**IN THE HON'BLE NATIONAL GREEN TRIBUNAL
EASTERN ZONE BENCH, KOLKATA**

O.A. No. 26/2023/EZ

**SUPPLEMENTARY AFFIDAVIT ON BEHALF OF RESPONDENT
No.3 i.e. NATIONAL HIGHWAYS AND INFRASTRUCTURE
DEVELOPMENT CORPORATION LIMITED (NHIDCL) IN TERMS
OF LIBERTY GRANTED BY THE ORDER DATED 12.01.2024 OF
HON'BLE NATIONAL GREEN TRIBUNAL (NGT), EASTERN ZONE
BENCH, KOLKATA IN THE OA NO. 26/2023/EZ IN THE MATTER
OF PI VANRAMCHHUANGI V/s UOI & ORS**

Updated status as on 24.01.2024

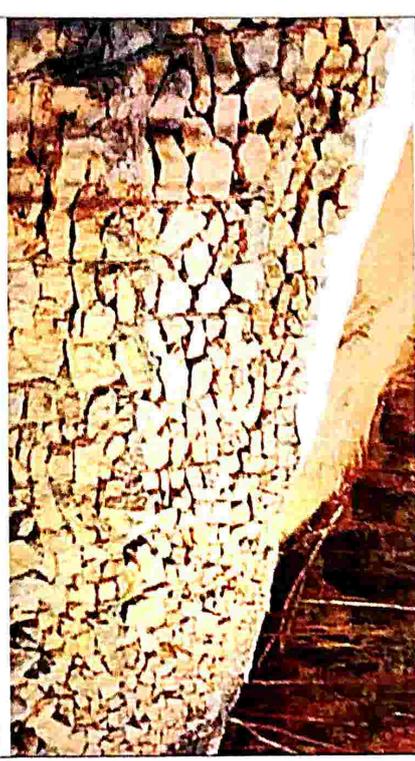
Lunglei District		Compliance	
S/No	Spill Bank	PCCF Comment	Compliance
1	Spill Bank No. 1, Tawipui North-II Village Area Chainage: Km 251+400	Unauthorized and currently in use for dumping of muck causing continuous damage to the environment. Operated without proper adequate protection structures such as Gabion/retaining wall, drainage systems, Check dams, compaction, vegetative measures etc.	(i) The Correct chainage is 251+040. (ii) No initial objections made by District Administration nor the Forest Department. (iii) The Spill Bank is authorized as approval is through VCP. The VCPs are vested with powers for management of land as per Lushai Hill Act 1953. (iv) There are no existing guidelines for approval of non-forest area as public are practicing Jhum Cultivation on lands along the Highway and as such approval is not necessitated. (i) The capacity of the spill bank and its capacity is as per the design. (ii) The Gabion wall is constructed at site. Sodding/Turfing, Drain channelization and Re-vegetation has been completed. (iii) The Capacity of this Spill Bank is 41209 Cum and 39000 Cum of Soil has been dumped.

Additional Remarks	Appears already overloaded beyond capacity posing further threats to the environment, vegetation and pollution of the nearby water bodies. Not suitable for further use	There are no nearby water bodies, therefore, chances for polluting the water bodies are not true. Upto the design capacity, dumping can be done.
	Photograph

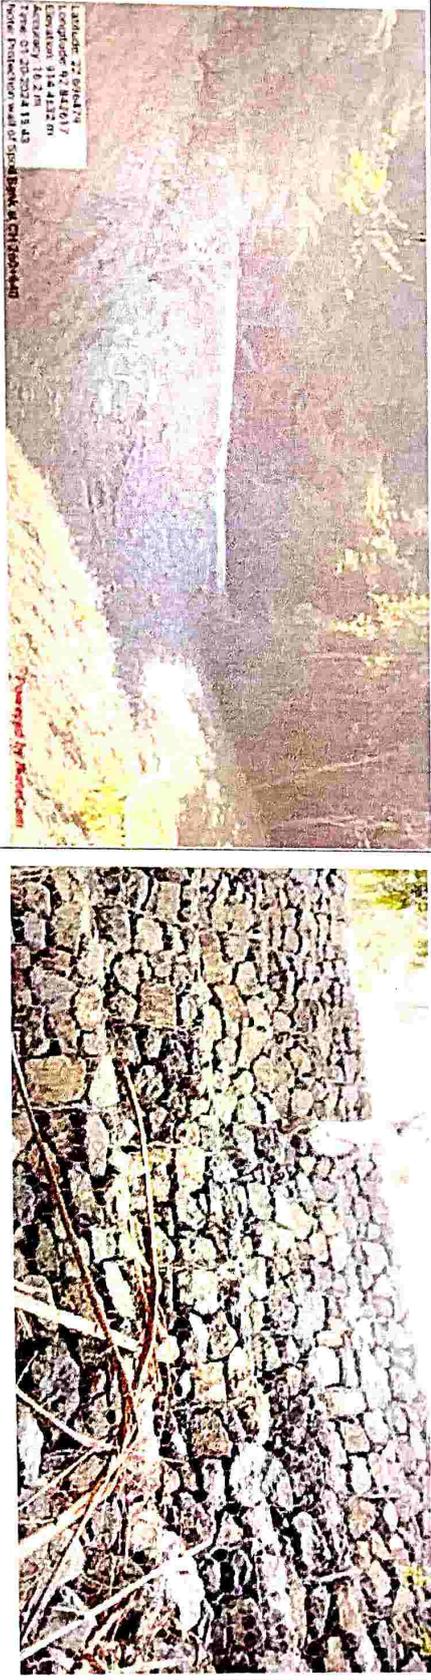
Sl no	Spoil Bank	PCCF Comment	Compliance
2	Spoil Bank No. 4, Tawlpui North-II Village Area Chainage: 231+840 KM	Unauthorized and currently in use for dumping of muck causing continuous damage to the environment. Operated without proper adequate protection structures such as Gabion/retaining wall, drainage systems, Check dams, compaction, vegetative measures etc. Appears already overloaded beyond capacity posing further threats to the environment, vegetation and pollution of the nearby water bodies. Not suitable for further use	<p>(i) The Correct chainage is 253+840.</p> <p>(ii) No initial objections made by District Administration nor the Forest Department.</p> <p>(iii) The Spoil Bank is authorized as approval is through VCP. The VCPs are vested with powers for management of land as per Lushai Hill Act 1952.</p> <p>(iv) There is no existing guidelines for approval of non-forest areas as public are practicing Jhum Cultivation on lands along the Highway and as such approval is not necessitated.</p> <p>(v) The capacity of the spoil bank and its capacity is as per the design.</p> <p>(vi) The Gabion wall is constructed at site, Sodding/Turning, Drain channelization and Re-vegetation has been completed.</p> <p>(vii) The Capacity of this Spoil Bank is 56209 Cum and 52000 Cum of Soil has been dumped.</p> <p>There are no nearby water bodies, therefore, chances for polluting the water bodies is not true.</p> <p>Upto the design capacity, dumping can be done.</p>

Additional Remarks		Photograph	
		 <p> CHAINAGE: 231+840.00 ELEVATION: 1015.558175 m AZIMUTH: 312.3 m DATE: 07/20/2024 16:24 Note: Comp. Drawing work in progress of Spoil Bank No. 4, Tawlpui </p>

Spoil Bank CH-272+884 to 272+914

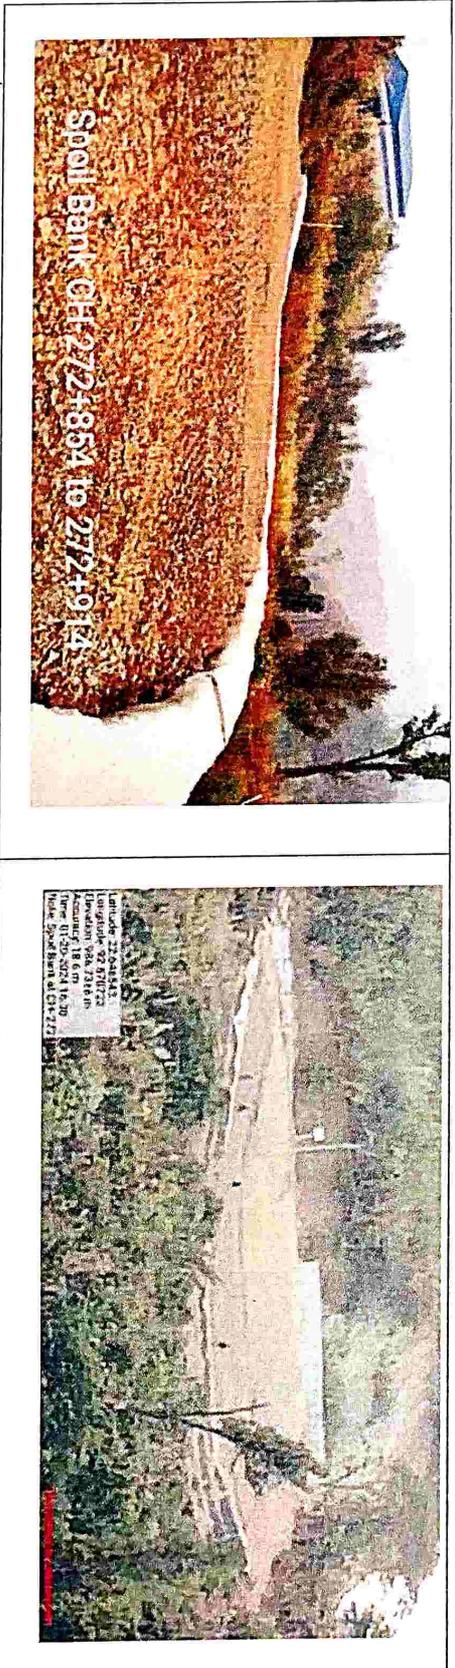
Slno	Spoil Bank	PCCF Comment	Compliance
6	<p>Spoil Bank No. 11, Thingfal Village Area Chainage: 272+884 KM</p>	<p>It was operated without approval from concerned authority, apparently causing damages to the environment. However, the spoil bank was already abandoned/closed and no longer in use at the time of inspection.</p> <p>A small structure of Gabion wall was found being constructed recently although the site was already closed and sparsely covered with natural vegetation.</p>	<p>(i) No initial objections made by District Administration nor the Forest Department. (ii) The Spoil Bank is authorized as approval is through VCP. The VCPs are vested with powers for management of land as per Lushai Hill Act 1953. (iii) There are no existing guidelines for approval of non-forest area as public are practicing Jhum Cultivation on lands along the Highway and as such approval is not necessitated.</p> <p>(i) The capacity of the spoil bank and its capacity is as per the design. (ii) The Gabion wall is constructed at site. Sodding/Turfing, Drain channelization and Re-vegetation has been completed. (iii) The Capacity of this Spoil Bank is 28359 Cum and 26500 Cum of Soil has been dumped.</p>

<p>Additional Remarks Photograph</p>	<p>During operation of the site, it is evident that environmental disturbance was caused due to dumping of muck to a certain large extent as evidenced by nearby damaged vegetation and landscapes.</p>	<p>No environmental disturbance is caused as the dumped soil is within the area of Spoil Bank. The photograph of Spoil Bank can be seen, wherein, the Gabion wall has been constructed. There has been no damaged vegetation or landscapes.</p>

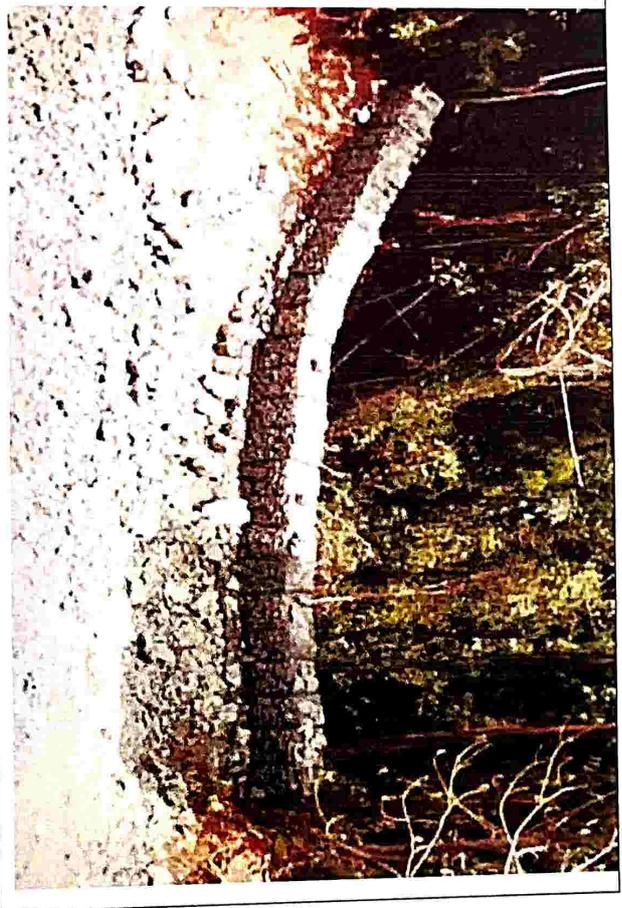
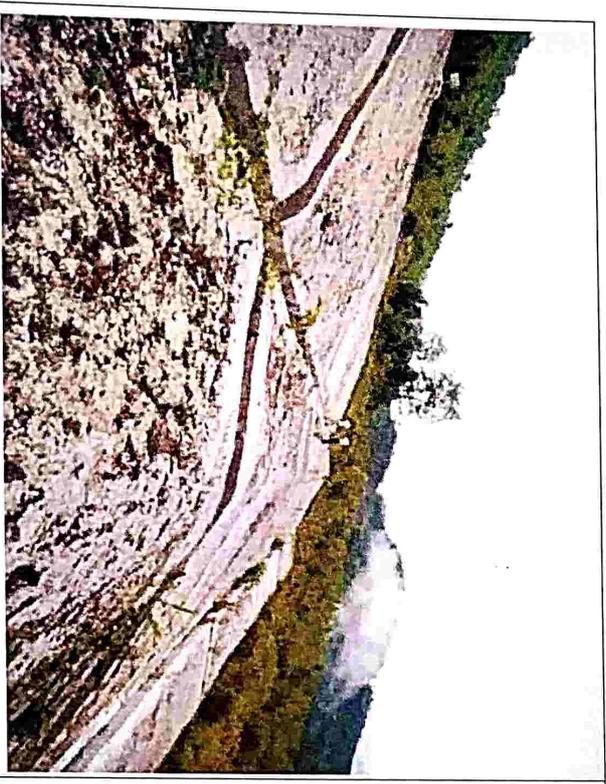
Sl no	Spill Bank	PCCF Comment	Compliance
3	Spill Bank No. 02, Lower Salkah Village Area Chainage: 307+910 KM	This spill bank was authorized by concerned Deputy Commissioner. Compaction of the site was done and maintained by constructing a number of drains. The site was closed and no longer in use.	No Comments to offer. No Comments to offer. The Capacity of this Spill Bank is 39802 Cum and 35500 Cum of Soil has been dumped.
Additional Remarks			
Photograph

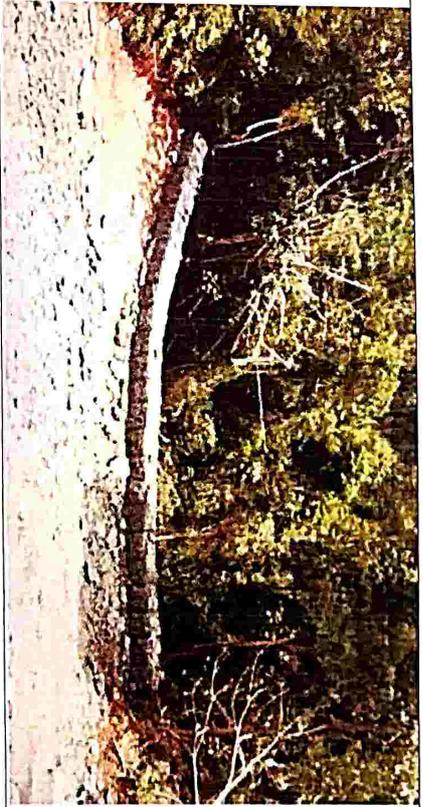
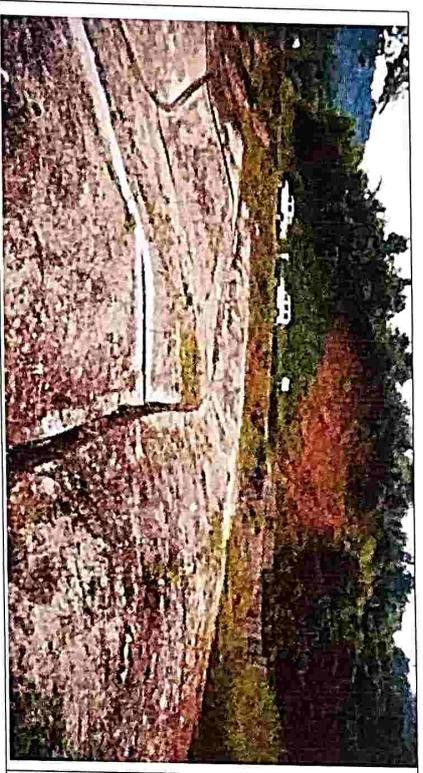
Sl no	Spill Bank	PCCF Comment	Compliance
4	Spill Bank No. 04, Lower Salkah Village Area Chainage: 309+115 KM	This spill bank was authorized by concerned Deputy Commissioner. Compaction of the site was done and maintained by constructing a number of drains. The site was closed and no longer in use.	No Comments to offer. No Comments to offer. The Capacity of this Spill Bank is 19901 Cum and 17650 Cum of Soil has been dumped.
Additional Remarks		Photograph

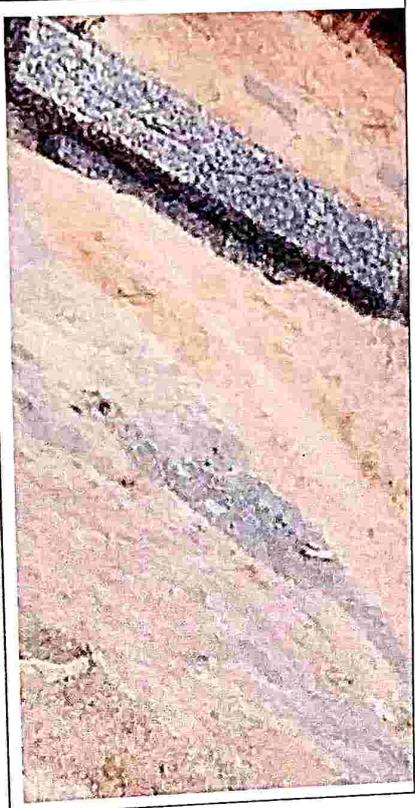
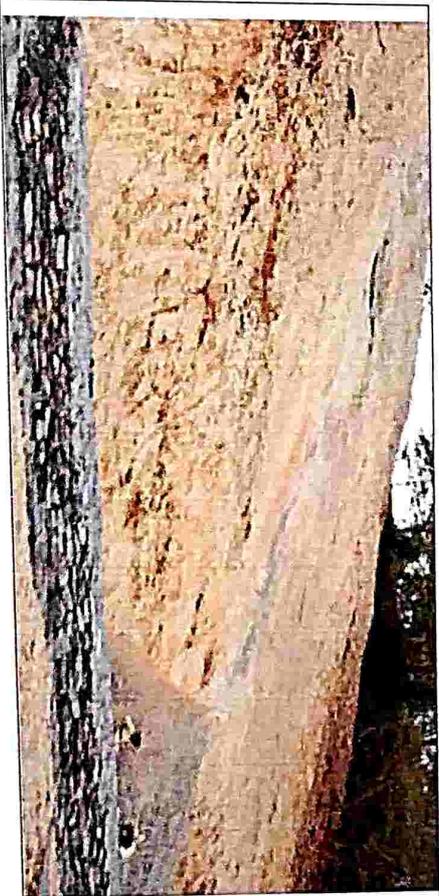
Sl no	Spill Bank	PCCF Comment	Compliance
2	Spill Bank No. 06 Ambyu Village Area Chainage: 342+700 KM	Unauthorized and in use. Causing environmental damages due to over dumping of the muck No adequate or appropriate protection measures found except for a very thin layer of small Gabion Wall constructed at the bottom of the site which was extremely inadequate to hold the dumped spoils. Not suitable for further use without adequate protective structures and approval of competent Authority, concerned District administration.	(i) No initial objections made by District Administration nor the Forest Department. (ii) The Spill Bank is authorized as approval is through VCP. The VCPs are vested with powers for management of land as per Lushai Hill Act 1953. (iii) There is no existing guidelines for approval of non-forest area as public are practicing Jhum Cultivation on lands along the Highway and as such approval is not necessitated. No Environmental damage has been done as barrier through Gabion wall has been made for spillage. The Capacity of this Spill Bank is 28940 Cum and 26430 Cum of Soil has been dumped. Up to the design capacity, dumping can be done. Gabion Wall is already constructed at Project site. This Spill Bank is complete with Landscape identification, Approach, Base preparation, Compaction and Gabion wall have been completed. The left-over sodding/turfing, Drain Channelization and Re-vegetation/plantation is also completed. Adequate protection measures taken and approval is available.

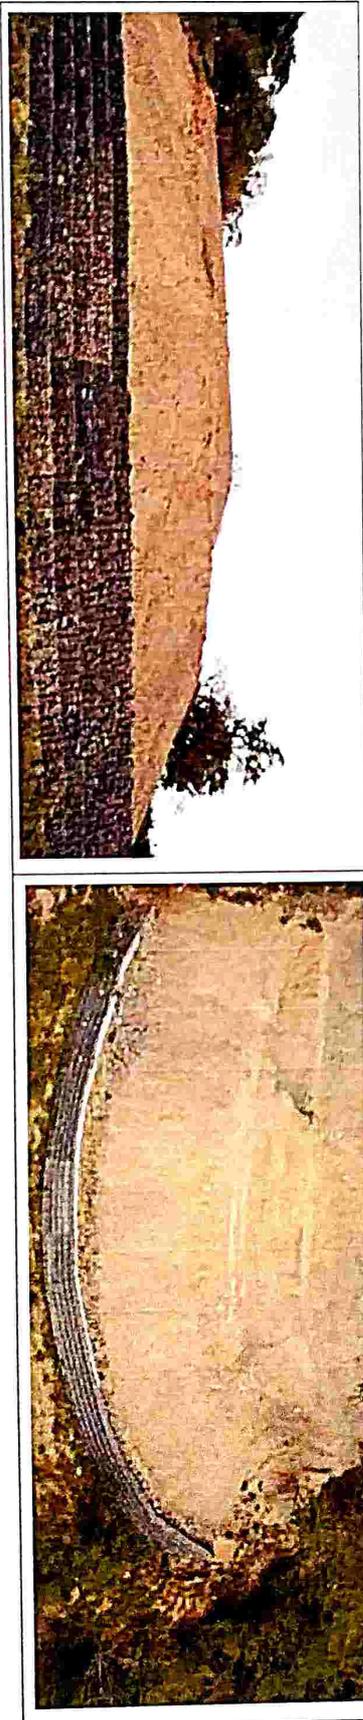
Sl no	Spoil Bank	PCCF Comment	Compliance
3	Spoil Bank No. 07 Thelva Village Area Chainage: 348+530 KM	Unauthorized and in use. Causing environmental damages due to over dumping of the muck	(iii) No initial objections made by District Administration nor the Forest Department. (iv) The Spoil Bank is authorized as approval is through VCP. The VCPs are vested with powers for management of land as per Lushai Hill Act 1953. (iii) There are no existing guidelines for approval of non-forest area as public are practicing Jhum Cultivation on lands along the Highway and as such approval is not necessitated. No Environmental damage has been done as barrier through Gabion wall has been made for spillage. The Capacity of this Spoil Bank is 94500 Cum and 89500 Cum of Soil has been dumped. Up to the design capacity, dumping can be done. Gabion Wall is already constructed at Project site. This Spoil Bank is complete with Landscape Identification, Approach, Base preparation, Compaction and Gabion wall have been completed. The left-over sodding/turfing, Drain Channelization and Re- vegetation/plantation is also completed. Adequate protection measures taken and approval is available.

Additional Remarks	Not suitable for further use without adequate protective structures and approval of competent Authority, concerned District administration.	
	Photograph
